HSS Modification Note for VARIAN STATORS

EEN-026
Eng. to Eng. Note
2009-04

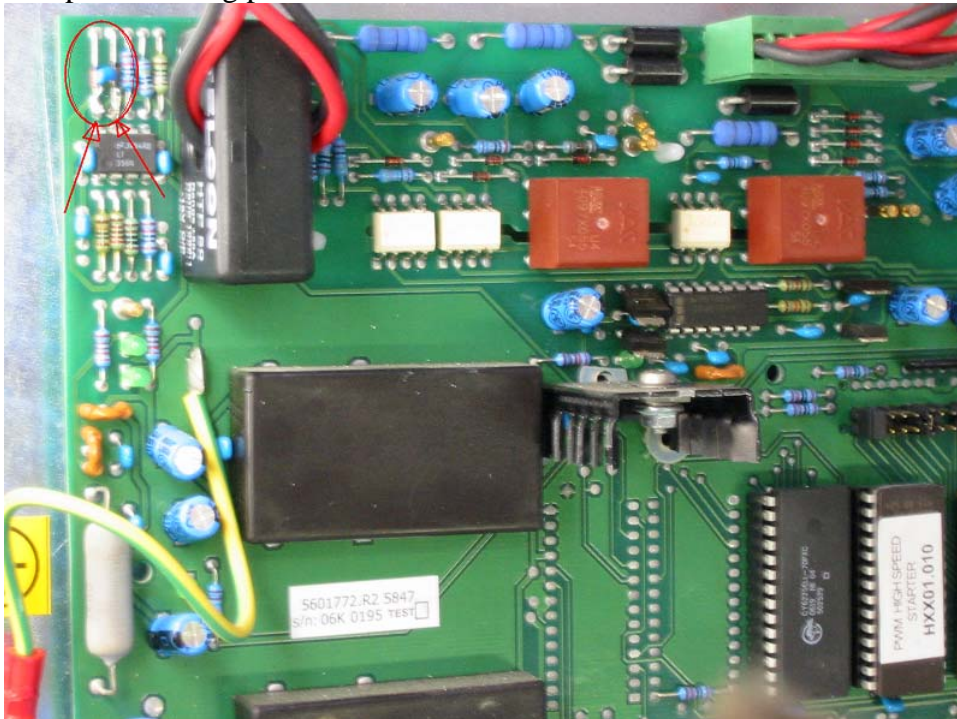
Varian Statots requires an 220pF filter capacitor on short circuit current sensing circuit according to following illustrations:

Locate the current sensing section on HSS control board and solder the capacitor directly on the diodes anodes as per following picture:

n.1 220pF ceramic capacitor 36Vdc minimum voltage
